REVISED RESPONSE TO REQUEST FOR ADDITIONAL INFORMATION

APR1400 Design Certification

Docket No. 52-046

RAI No.: 252-8299
SRP Section: 03.07.02 – Seismic System Analysis
Application Section: 3.7.2
Date of RAI Issue: 10/19/2015

Figure 4. Tapered Section in Primary Shield Wall

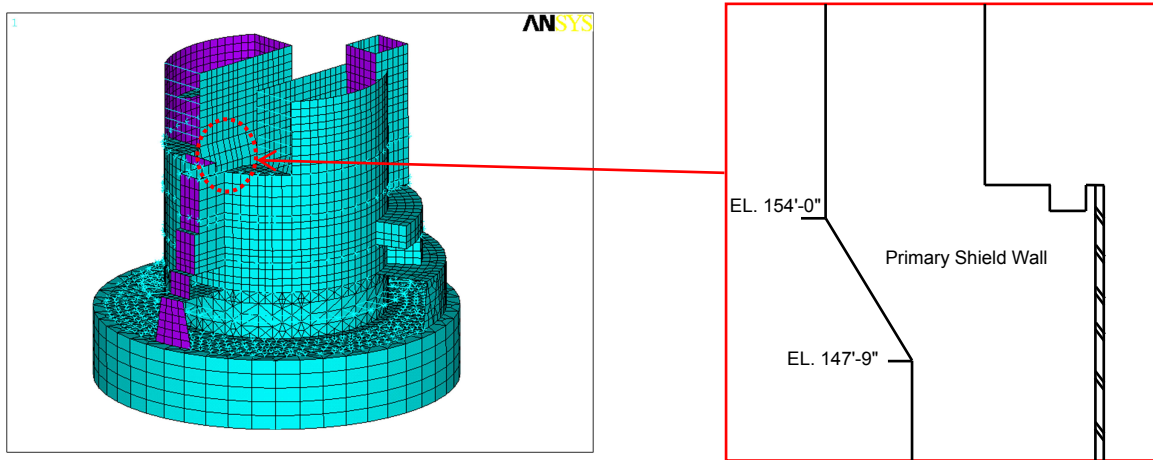
As described in Section 3.2.10 and shown Figure 3-3 in APR1400-E-S-NR-14002-P, shell elements are used to model the shield wall portion of the primary shield wall (PSW) from EL 130' to EL 191.' Given the geometry of the PSW, the use of thick shell elements may be more appropriate for this portion of the PSW. he geometry of the PSW, the use of thick shell elements may be more appropriate for this portion of the PSW. Additionally, based on Figure 3-3, a portion of these walls modeled with shell elements, appears to be not in plane with respect to the plane of each respective wall. Therefore to assist the staff in evaluating the adequacy of the FEM for the PSW, the staff requests the applicant to clarify why the shell element selected for the PSW model is appropriate as opposed to using a thick shell element formulation. Additionally, please describe the modeling approach and the basis of the shell portion of the walls including the location of plates oriented in non-parallel planes.

- c) The original SASSI program was developed in the 1980's and has only the LCCT9 thin shell element, which was adopted from the SAP IV structural analysis program. This same version of the SASSI code was adopted by many company-specific versions of SASSI. ACS SASSI 2.3 also has only the LCCT9 thin shell element. Many versions of SASSI, including ACS SASSI 2.3, do not have thick shell element available for structural modeling. This is the reason why thick shell elements have not been used for modeling the PSW by the ANSYS program.

Use of thick or thin shell elements does not significantly affect the overall structural stiffness since the main stiffness of the shell structures (containment shell, PSW, SSW, etc.) are primarily due to in-plane stiffness.

The thickness and center axis of the PSW section are changed over EL. 147'-9" through EL. 154'-0", as shown in Figure 4. The portion of wall which is not in plane with respect to the plane of respective walls in Figure 3-3 of APR1400-E-S-NR-14002-P was intentionally modeled to represent the contour of the PSW.

Figure 5. Connection between RCS Supports and Solid Elements

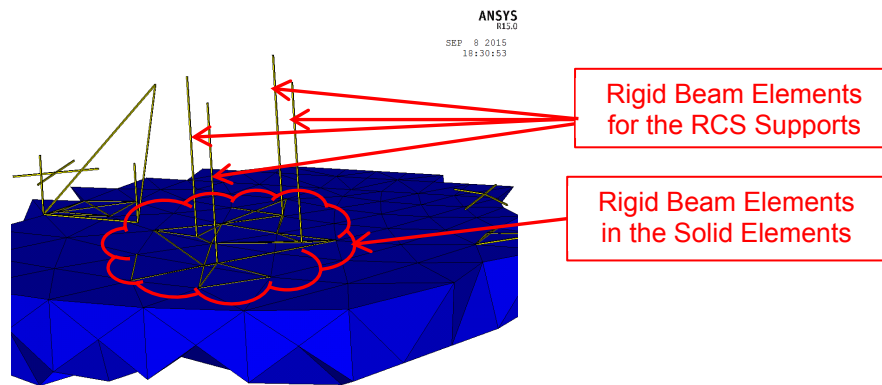
Staff review of APR1400-E-S-NR-14002-P finds that the nuclear island finite element model includes locations at which beam elements connect with solid elements (e.g. connections between the reactor coolant system model and the containment internal structure model). However, the staff did not find a description of how the degree of freedom compatibility is addressed for transitions between beam and solid elements. Therefore the staff requests the applicant to provide such description, including a graphical representation of the transition between beam and solid elements.

- d) The degrees of freedom compatibility condition between the beam elements of the reactor coolant system (RCS) and solid elements of the primary shield wall (PSW) and the secondary shield wall (SSW) was satisfied by using the rigid beam elements at the beam-to-wall support points covering the footprint of the RCS support brackets. The RCS supports are modeled as rigid beam elements and connected with other rigid beam elements in the solid elements which represent the PSW and the SSW.

Figure 5 shows the connection between the RCS supports (rigid beam) and the building model (solid elements). Technical report APR1400-E-S-NR-14002-P will be revised, as indicated in Attachment 3 to this response to incorporate the description of the beam-to-solid element connection.
